Shoppers at Hyde Park

CITY OF LAS VEGAS INTER-OFFICE MEMORANDUM		DATE: January 27, 2021
TO: Land Development Services Department of Building & Safety		FROM: Albert Sung, P.E. Flood Control Project Engineer Department of Public Works
SUBJECT:	Drainage Study for: Shoppes at Hyde Park	COPIES TO: Lochsa Engineering
Cross Streets:	SEC of Charleston Blvd. & Arville Avenue	Carpi Enterprises LLC
File Number:	F:\Depot\DSMemos\DS5394B.doc	Bart Anderson, P.E., DevCo
Parcel Number:	162-06-510-001 & 162-06-512-002	CCRFCD
Zoning Action:	20-0154-SDR1 & 20-0154-VAR1	
FEMA Flood Zone	YES NO X	
Proposed Storm Drain	YES NO X

**Addendum to the
Technical Drainage Study
For
Shoppes at Hyde Park
(NEC of Charleston Blvd & Arville St.)**

COMMENT LETTER

Split Flow - Arville (10year) Worksheet for Irregular Channel

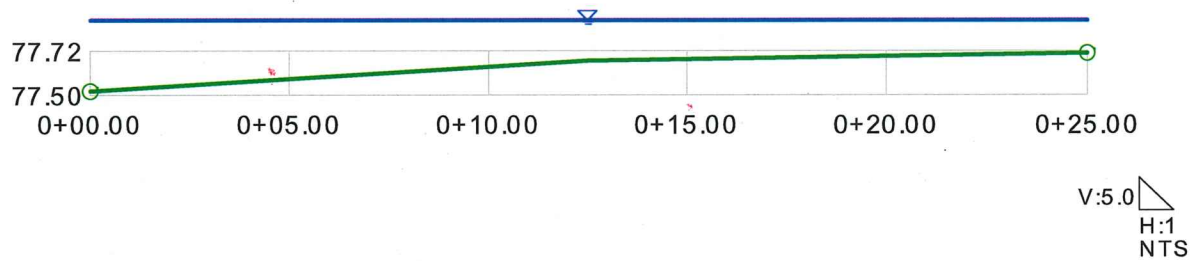
4. In the *Onsite Existing and Developed Conditions Drainage Maps* (DR1 and DR2): It appears that there shall be a flow split at the southern alley in *Arville Avenue* during a rainfall event. Provide a flow split calculation and revise the 10-year/100-year flows in the alley and double check the proposed finished floor elevation of the buildings adjacent to the alley per criteria accordingly.

For the 10yr storm event, the flow split calculation shows that 35.80cfs will continue north along Arville and 16cfs will split east in the alley way.

COMMENT #6

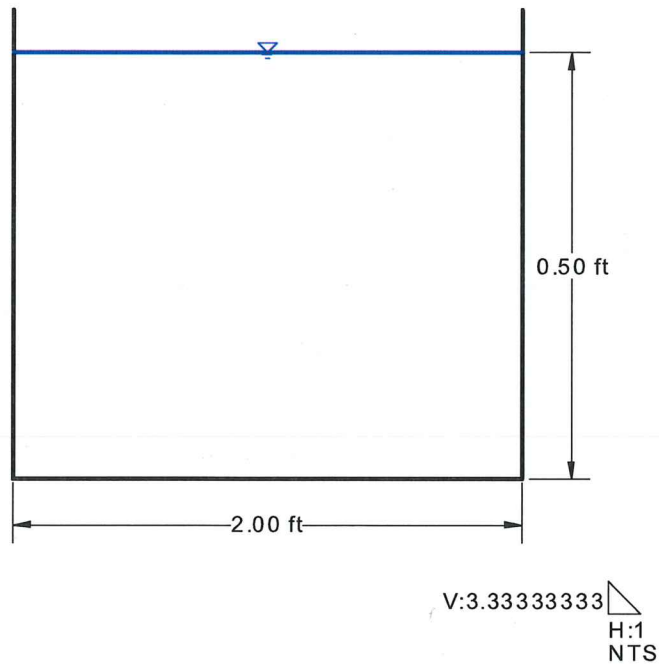
6. A solid grout stem wall is proposed behind the sidewalk in *Charleston Boulevard* east of the proposed main entrance driveway. A sidewalk underdrain is proposed to convey the onsite flow to *Charleston* for discharge. The anticipated 100-year onsite flow from *Basin ND1* is 8cfs. It appears that the proposed single sidewalk underdrain is not capable of conveying the flow. Address and resolve in the next submittal.

Response 6: We have provided a SW Underdrain capacity calculation. A 2ft SW Underdrain has the capacity to convey 7.77cfs, which is nearly 8cfs. However, we have proposed two side by side SW underdrains. This design will provide an emergency over flow path if one of the SW underdrains were to get clogged.

If both SW Underdrains were 100% clogged, flow will pond and overtop the SW Underdrains and spill north into Charleston Blvd. Please note there is a 6ft wide opening (4ft width of two SW underdrains and 1ft extra on each side = 6ft) of the proposed flood wall where the two sidewalk Underdrains are located. The flood wall begins and ends at each side of the Sidewalk Underdrains from the east and west. Therefore, there is nothing blocking the flow from ponding and spilling north into Charleston Blvd.

D SECTION-CHARLESTON NOT TO SCALE

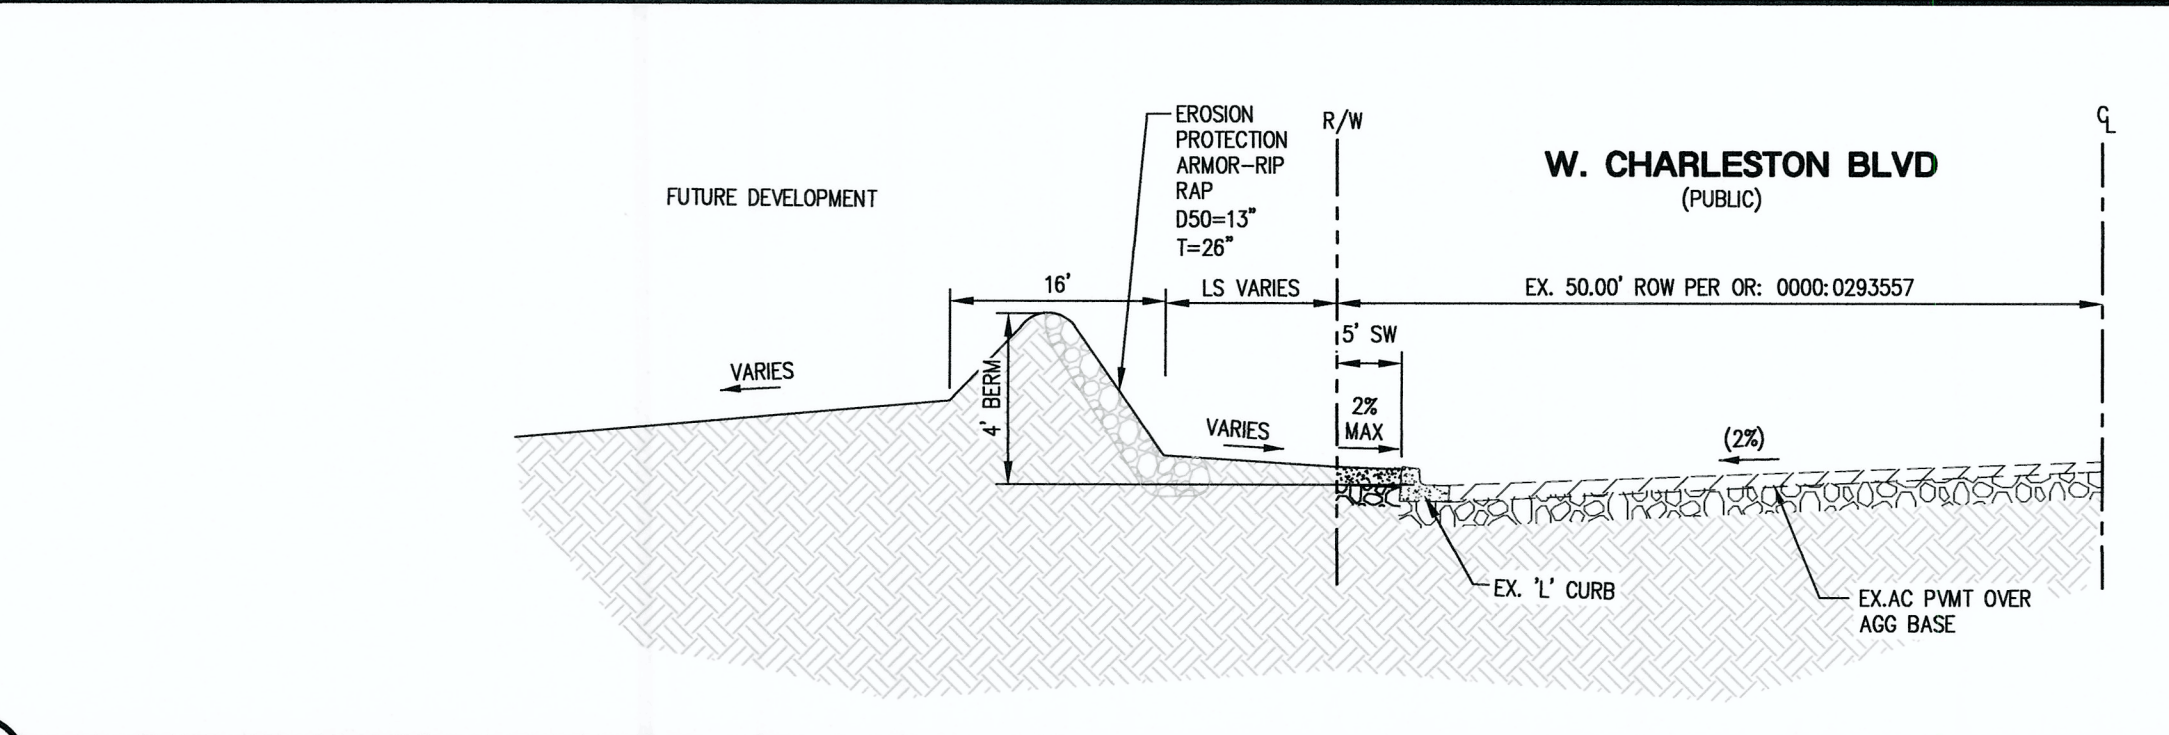
5. The anticipated 100-year flow in *Charleston Boulevard* is erosive and above and beyond the sidewalk. The proposed berm in *Charleston Boulevard* as shown in *Detail Section D/C6.01* has to provide erosion protection measures on the side facing the street. Review and revise the plan, detail and the construction note accordingly.

5. The anticipated 100-year flow in *Charleston Boulevard* is erosive and above and beyond the sidewalk. The proposed berm in *Charleston Boulevard* as shown in *Detail Section D/C6.01* has to provide erosion protection measures on the side facing the street. Review and revise the plan, detail and the construction note accordingly.

Response 5: Noted. We have provided a riprap calculation based on the 100yr velocity within Charleston Blvd. The riprap calculation shows 13-inch riprap is needed for erosion protection along the berm embankment that is facing the street. The Plans and construction note have been revised.

- 1.5' MAX DEEPENED FOOTING SEE ARCH PLAN
- INSTALL EROSION PROTECTION ARMOR ALONG LANDSCAPING FACING CHARLESTON BLVD (RIP RAP D50=1 1/2" THICKNESS=26")

SHEET No. DR1
SHEET 1 OF 2
OFFSITE HTE No.

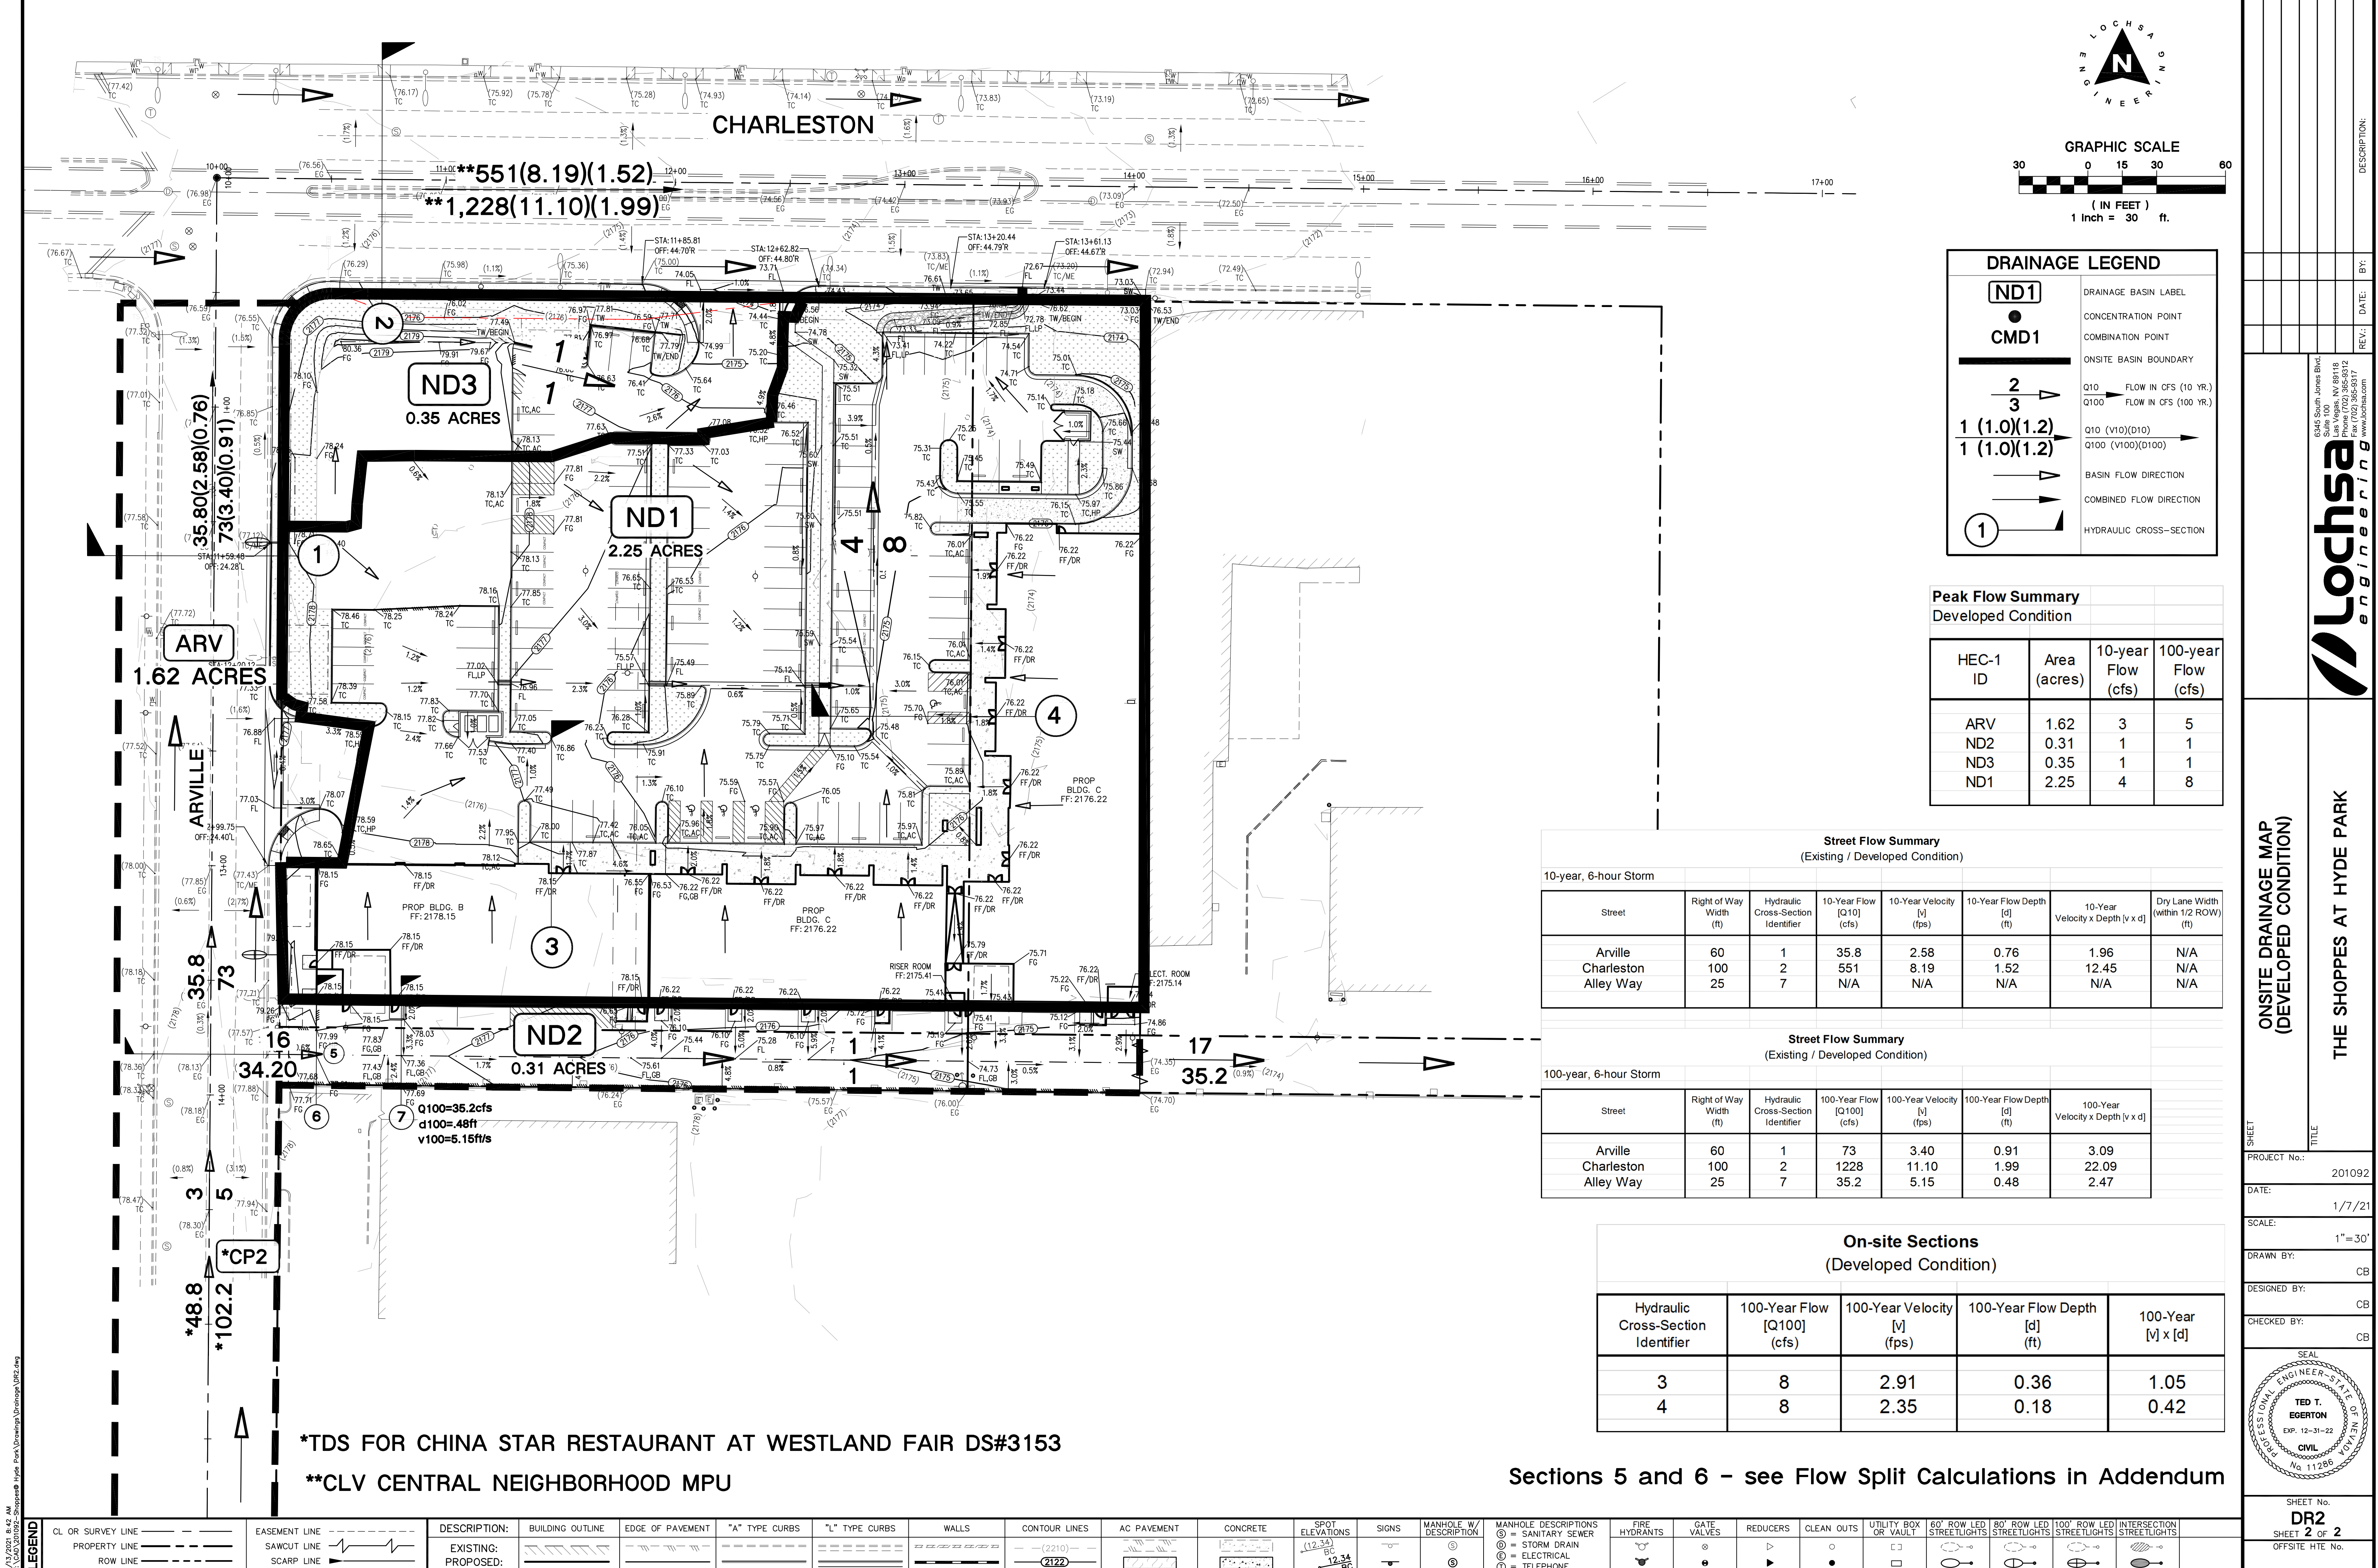
4. In the *Onsite Existing and Developed Conditions Drainage Maps* (DR1 and DR2): It appears that there shall be a flow split at the southern alley in *Arville Avenue* during a rainfall event. Provide a flow split calculation and revise the 10-year/100-year flows in the alley and double check the proposed finished floor elevation of the buildings adjacent to the alley per criteria accordingly.

Response 4: Noted. We have provided a flow split calculation at the southern alley way in Arville Avenue. We have provided a hydraulic section across Arville Avenue (Section 5) at the center of the alley way and we have provided another hydraulic section (Section 6) across the alley way at the upstream side of the Building 'B'. To determine the flow split values, we matched the specific energy elevation in the alley way with the WSE in Arville Avenue. We had to keep adjusting the discharge values until they matched elevations.

With these revised flows, we have revised the hydraulic section 1 for Arville Avenue (10yr / 100yr storm) to show the new depths and velocities. Revised hydraulic calculations with the revised flow rates have been provided. These have been adjusted on the Interim / Developed Drainage Plan (Figure DR2).

Sections 5 and 6 - see Flow Split Calculations in Addendum
